STATE OF CONNECTICUT  
CONNECTICUT SITING COUNCIL

APPLICATION OF AMERICAN TOWER CORPORATION  
(ATC) AND NEW CINGULAR WIRELESS PCS, LLC (AT&T)  
FOR A CERTIFICATE OF ENVIRONMENTAL  
COMPATIBILITY AND PUBLIC NEED FOR THE  
CONSTRUCTION, MAINTENANCE AND OPERATION OF A  
TELECOMMUNICATIONS TOWER FACILITY AT 701  
LYDALL STREET MANCHESTER, CONNECTICUT

DOCKET NO. 453

AMERICAN TOWER CORPORATION (ATC) and  
NEW CINGULAR WIRELESS PCS, LLC (AT&T)  
RESPONSES TO CONNECTICUT SITING COUNCIL PRE-HEARING QUESTIONS SET I

Existing with Proposed @ 90'  
700 MHz LTE Coverage

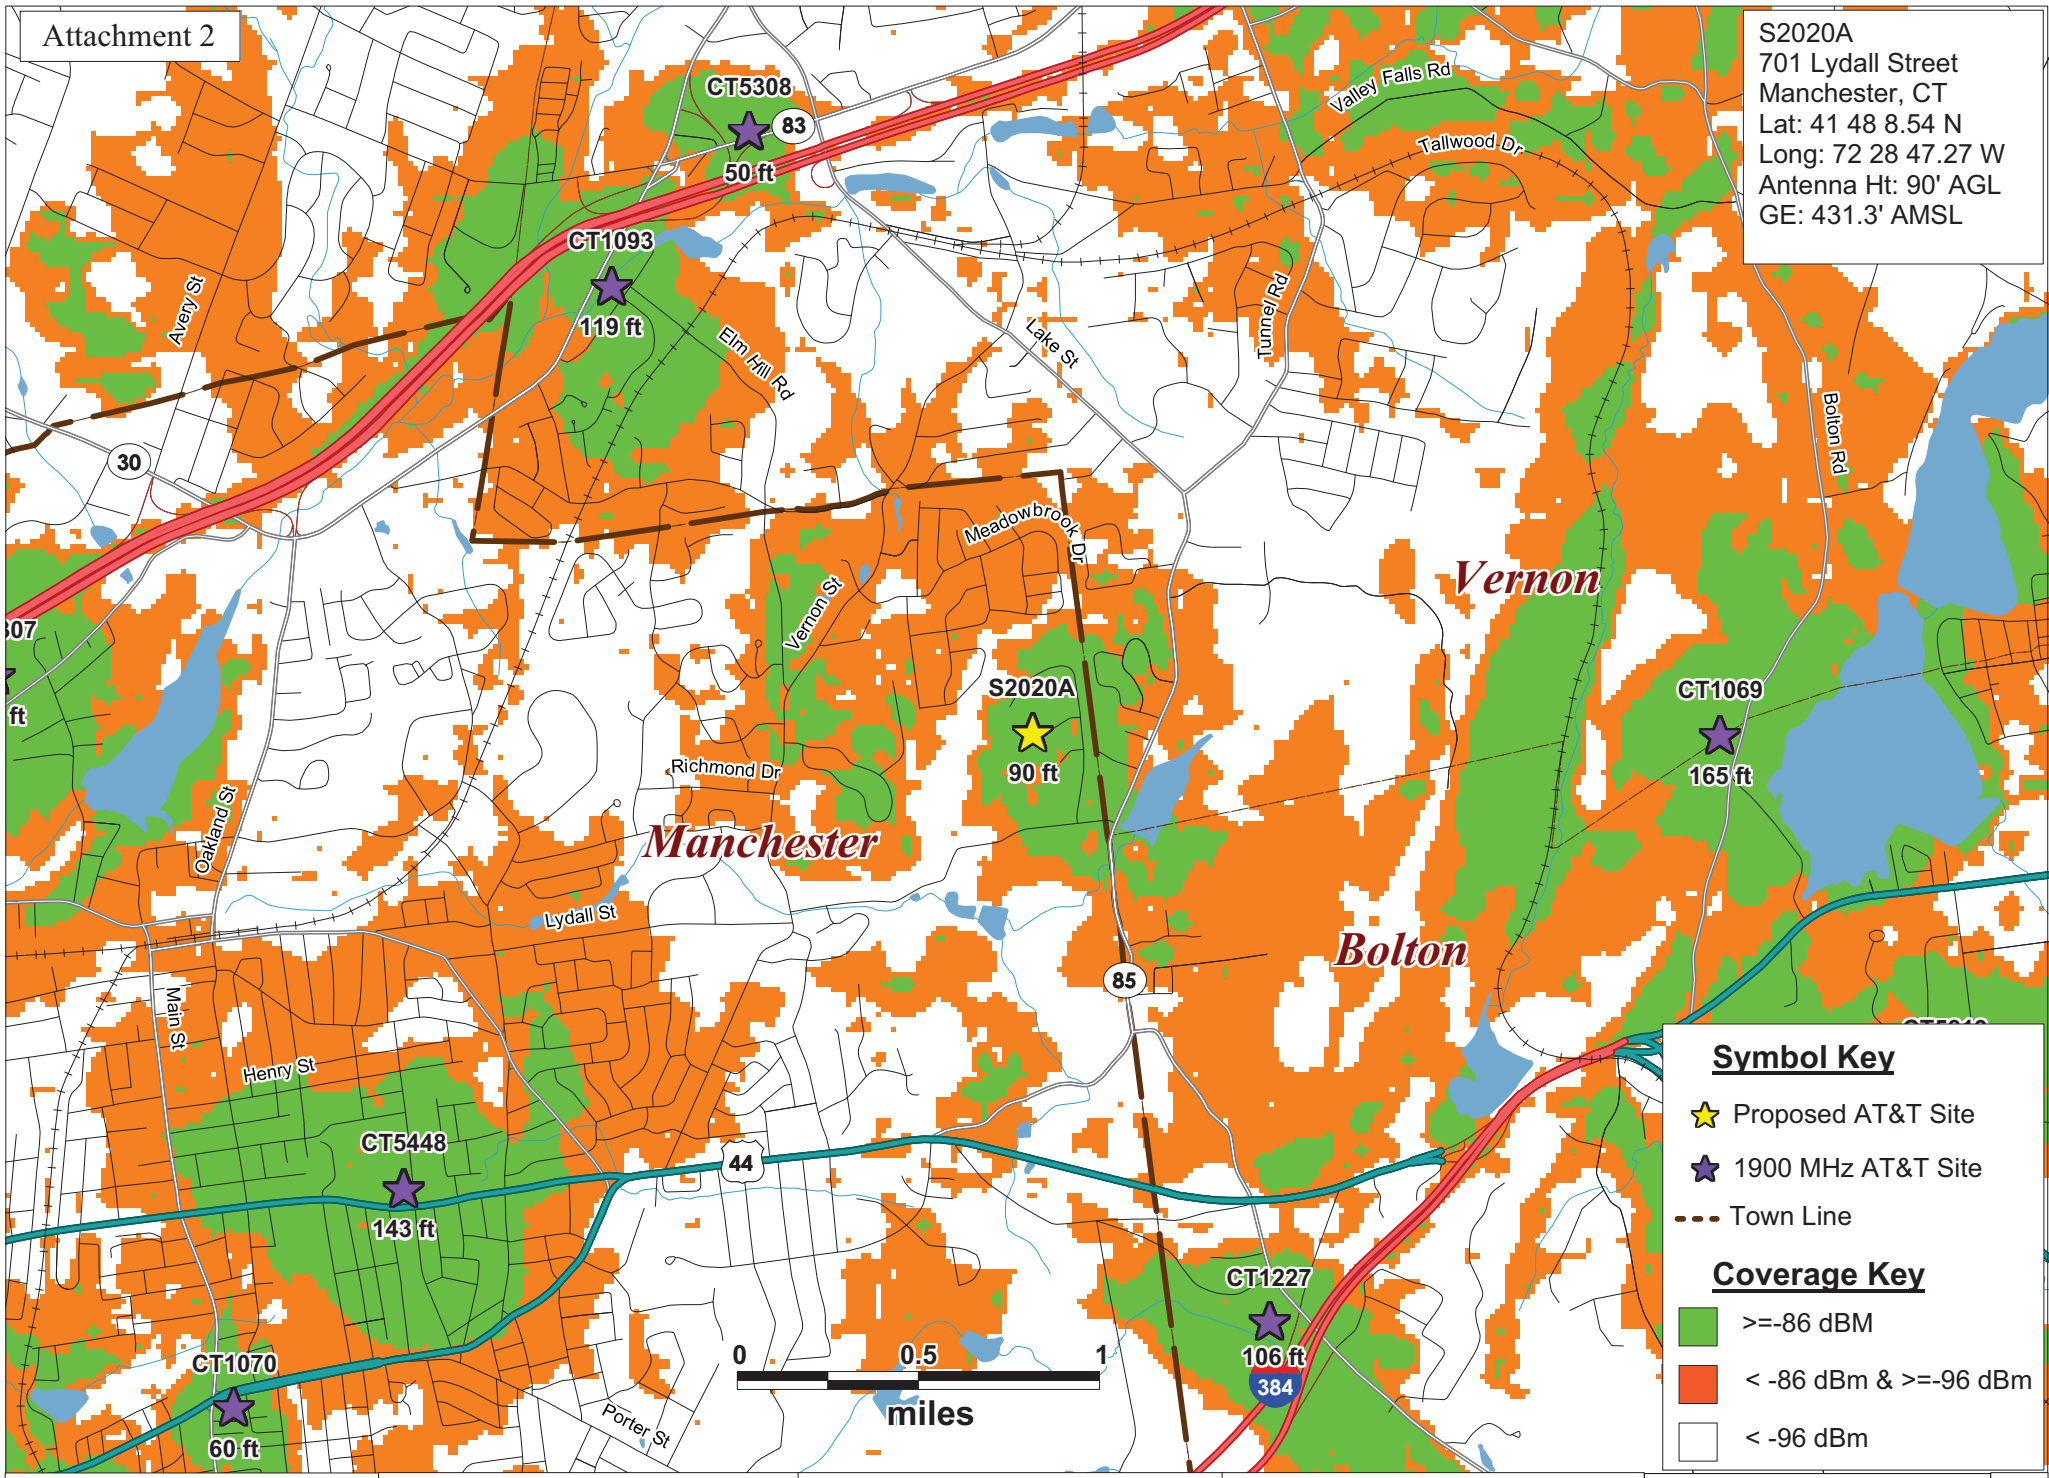
Q9. What is the lowest feasible height at which AT&T's antennas could fulfill the coverage objectives from the proposed facility? What problems would result if AT&T were to install antennas at a lower height? Submit a propagation map showing the coverage at ten feet below this height.

A9. *The minimum centerline required to meet the targeted coverage objectives for this search area is 100 AGL. As shown in the propagation maps included in Attachment 1 titled: "Existing with Proposed @ 90' 700 MHz LTE Coverage" and "Existing with*

*Proposed @ 90' 1900 MHz LTE Coverage", at the reduced height, substantial in-building and road coverage are lost within the targeted area.*

**Alternative Access Map**

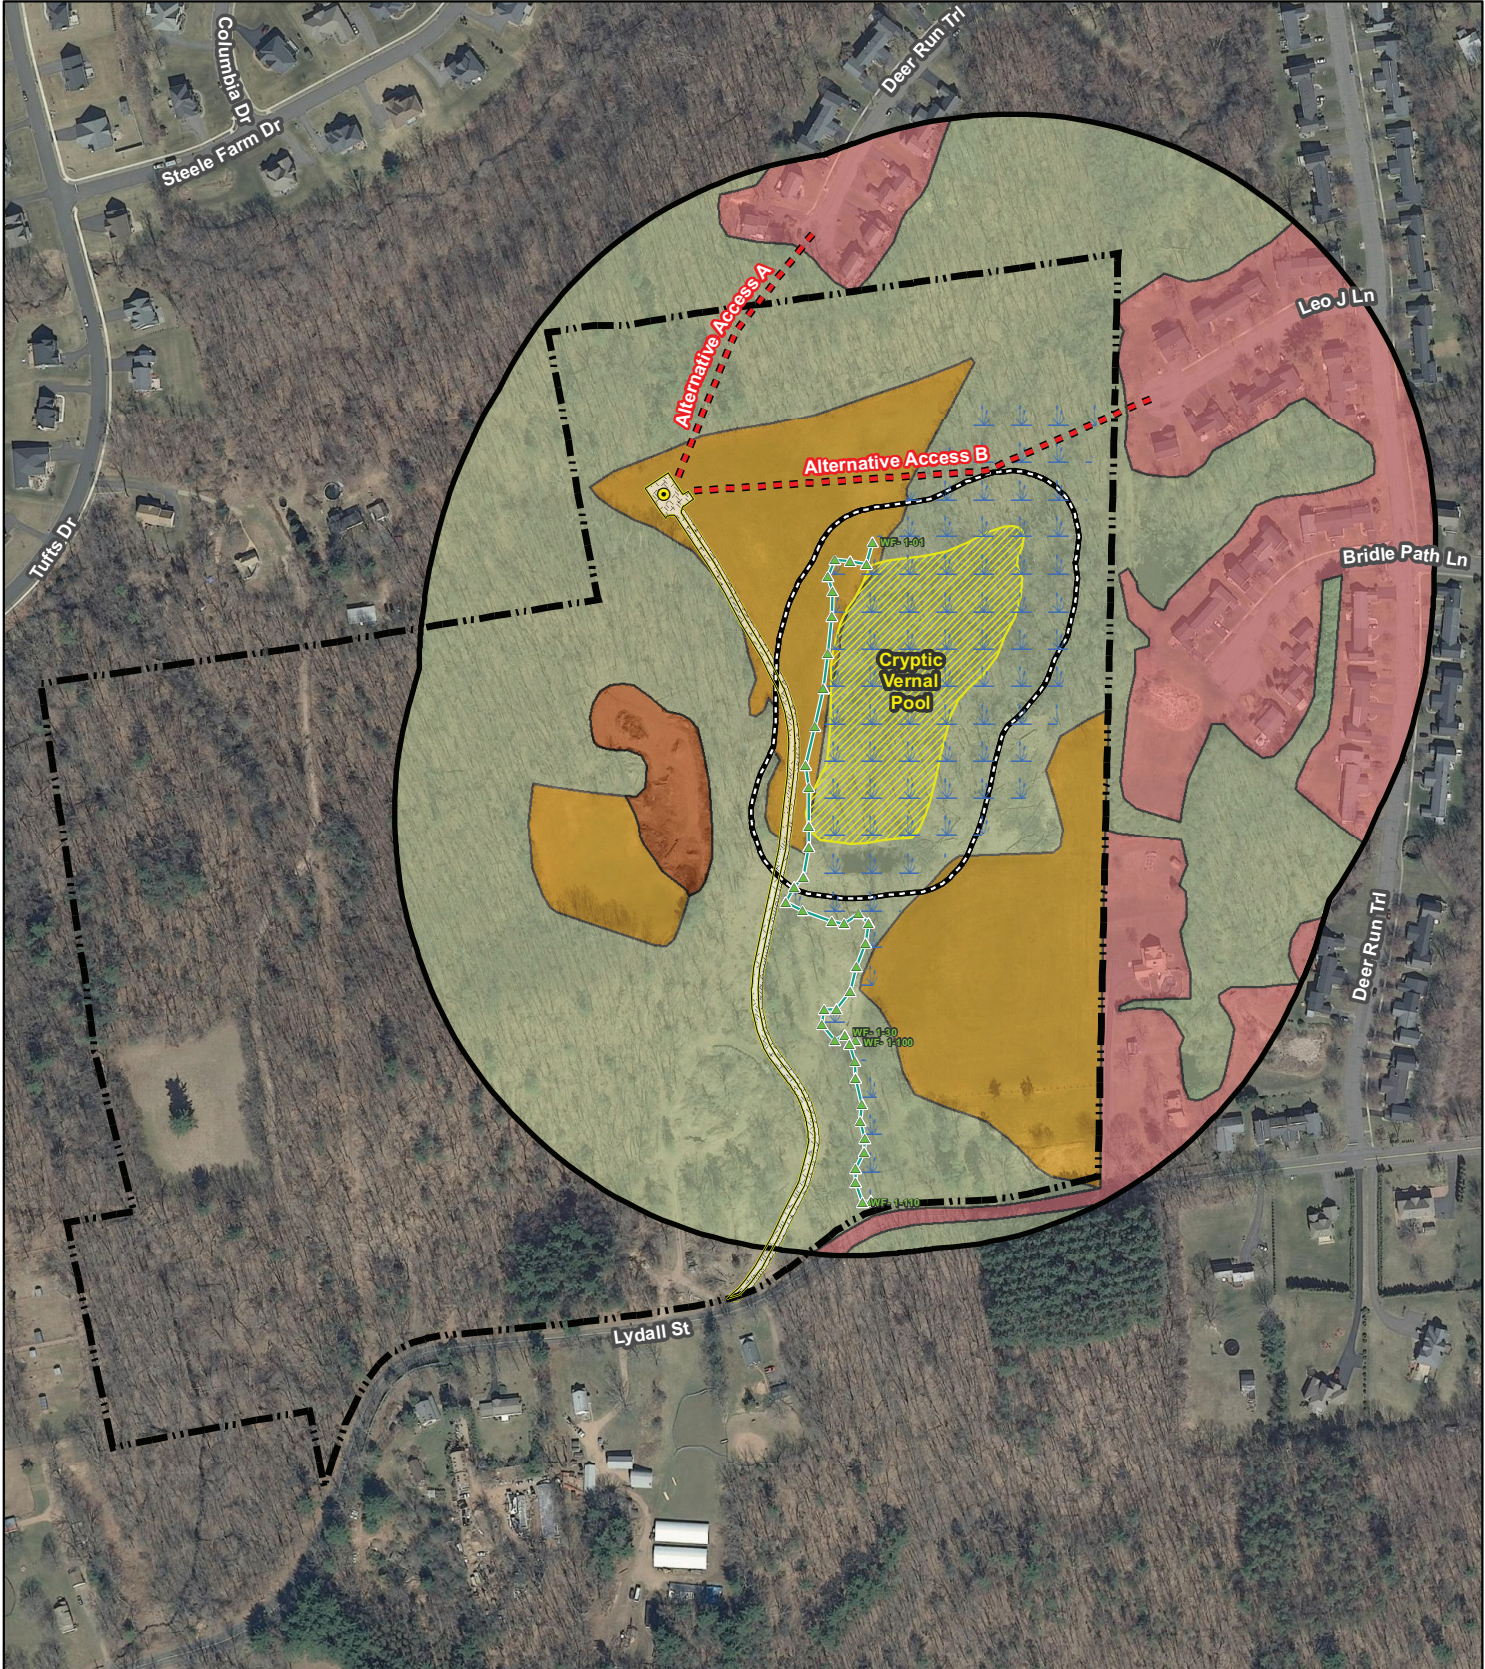
Q17. Provide a map showing any alternative access routes/utility runs that were considered for this proposed facility.

A17. *Two alternative routes were evaluated to access and provide utility services to the proposed telecommunication facility. These alternatives are shown on the Alternative Access Map provided in Attachment 3. The reasons they were not considered are as follows:*

*Alternative A – This access and utility routing would commence at the cul-de-sac at the end of Deer Run Trail (northeast of the proposed facility) and extend to the proposed facility. This access is located within a dense wooded area and would require the*

*removal of numerous mature trees. Furthermore, construction traffic and activities in and out of this area would be immediately adjacent to existing residential properties. The access and utility routing as proposed only require limited tree trimming, no mature tree removal and maintains access/utility construction on the host parcel.*

*Alternative B – This access would commence at the cul-de-sac at the end of Leo J Lane (east of the proposed facility) and run westward to the proposed facility. This access is located within a dense wooded area and would require the removal of numerous mature trees. In addition, this routing would require wetlands crossing/disturbance. The access and utility routing as proposed will have the least potential environmental impact (mature tree removal and wetland disturbance) and maintains access/utility construction on the host parcel.*

**Land Use Map**

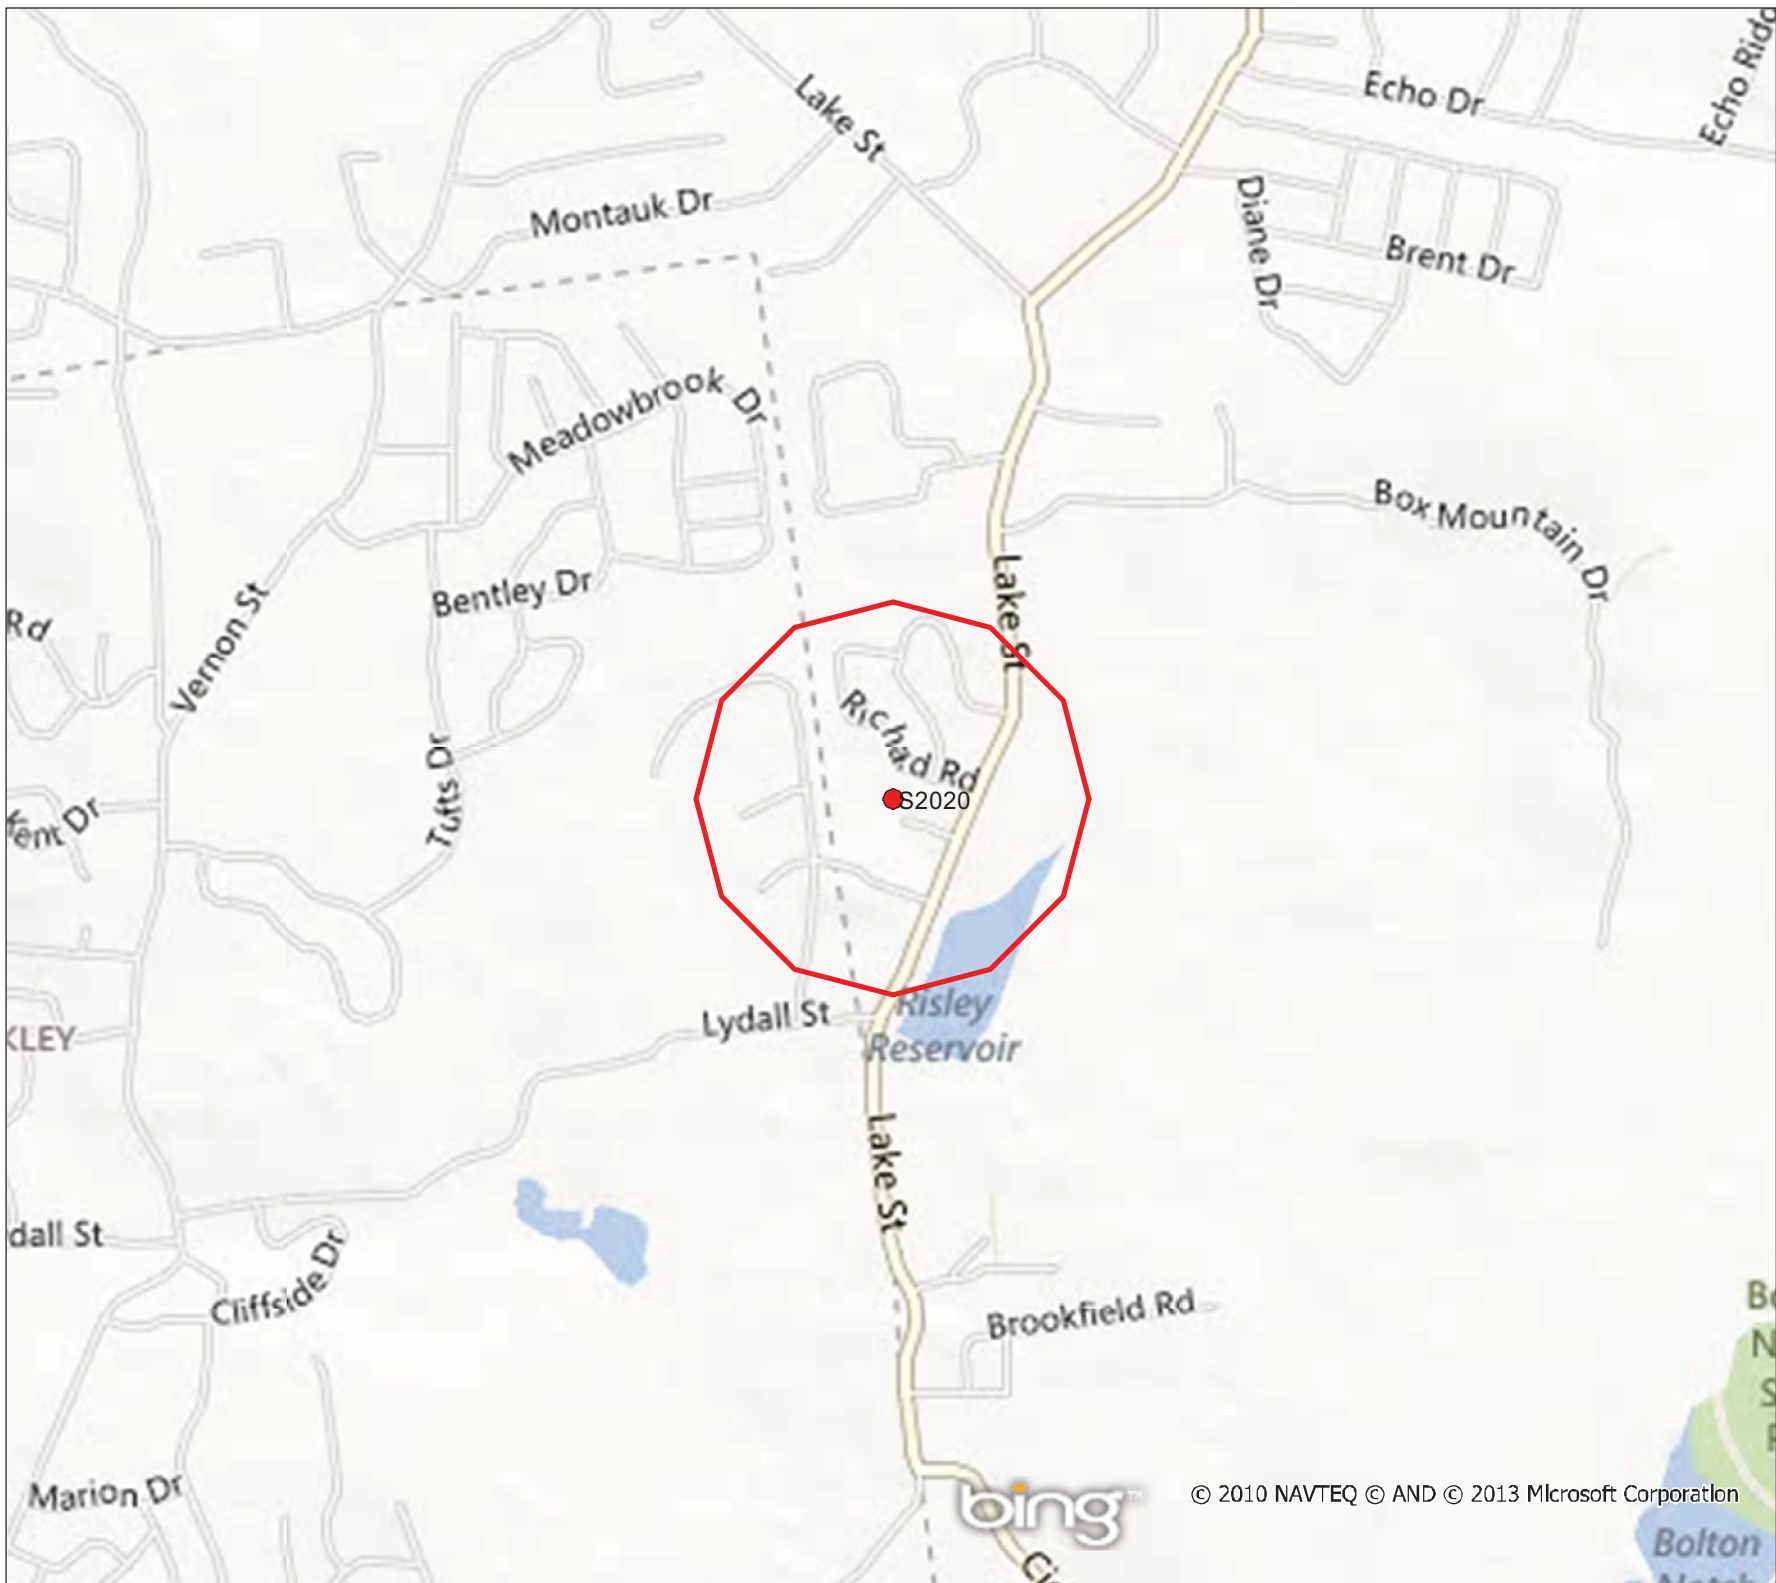
Q21. Characterize the land use within ¼ mile of the proposed facility.

A21. *Land use within ¼ mile of the proposed facility, not including the subject property, is dominated by developed residential properties. Please refer to the Land Use Map included in Attachment 4 which depicts the character of the surrounding area. Undeveloped, primarily wooded land that is located north and south of Deer Run Trail to the northeast of the proposed facility is owned by the Manchester Land Conservation Trust. This conservation land, known as Lydall Woods, encompasses approximately 30 acres for passive recreational use.*
